ITEM #2 D. R. Horton, Inc. requests Concept Plan approval for a townhome development, located at 1920 S 500 W in a proposed Low Density Residential (LDR) zone. Lakewood Neighborhood. Aaron Ardmore (801) 852-6404 aardmore@provo.org PLCP20190188

OSPREY TOWNS
 Concept Plan
 Sept 28, 2020

ATTACHMENT 1 – PROPOSED SITE PLAN

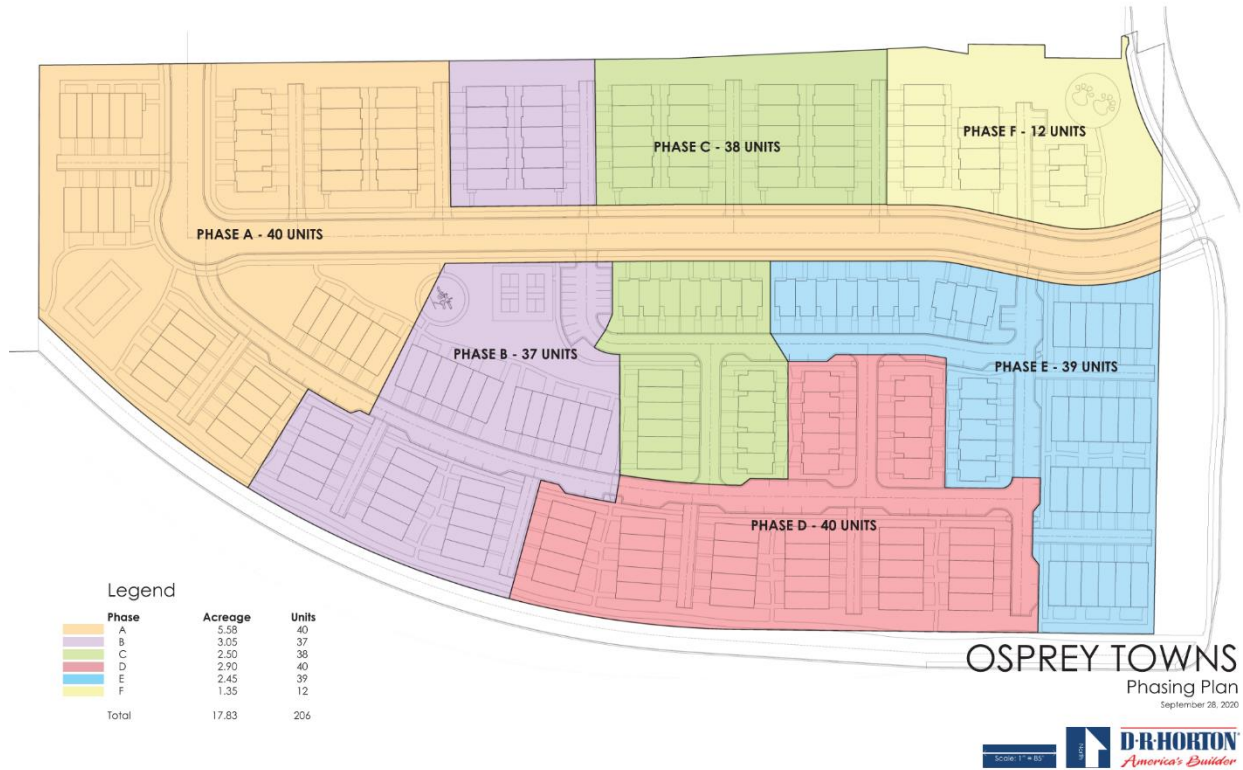
With 206 units and 889 parking spaces, the overall project will be parked at a rate of 4.31 spaces/unit. This parking supply exceeds what the City would require. Two and three-bedroom units would demand 2.25 spaces per unit, so the excess parking could help to mitigate concerns regarding visitor and overflow parking moving into adjacent neighborhoods.

The open space required in the LDR zone is twenty percent (20%) of the gross lot area. The 17.74-acre site would then require a minimum of 3.54 acres of open space. The concept plan shows 3.93 acres of "open space" including the south frontage, the western volleyball court, the central tot lot and pickleball court, and the park space in the northeast. However, that total also includes several pieces of land that fall within the required building setbacks as illustrated in attachment #3 of this staff report and cannot be counted towards the open space requirement. Section 14.14A.090 states that these spaces "must be massed" and that "landscaping within the required setbacks shall not be calculated towards meeting this provision." Additionally, staff previously agreed to

count as open space land along the Lakeview Parkway and along 500 West that is in city ownership because the developer agreed to improve, landscape and maintain these areas. The development agreement submitted does not include improvement and maintenance of these areas so they should not be counted in the open space calculations.

The project on a whole will come in at just over 11 units to the acres, which is less than the maximum of 15 permitted in the zone but still a dense project for the site. Although the proposal is for less density than what is permitted in the zone, the project design appears crowded and dense. The mix of unit types on public and private streets should help to bring variety through the site, but the concentration of buildings does not “maintain the residential character compatible with one-family housing” as stated in the purpose and objectives of the LDR zone.

Between the previous hearing on September 23rd, when this item was continued due to time constraints and this meeting, the applicant has failed to address staff concerns with the right-of-way, open space requirements and overall design. In fact, the applicant only compounded those concerns by adding more units to the property, bringing it further out of compliance with the LDR zone. Staff has in turn adjusted the recommendation to the Planning Commission.

Staff recommends that the Planning Commission deny the Concept Plan.
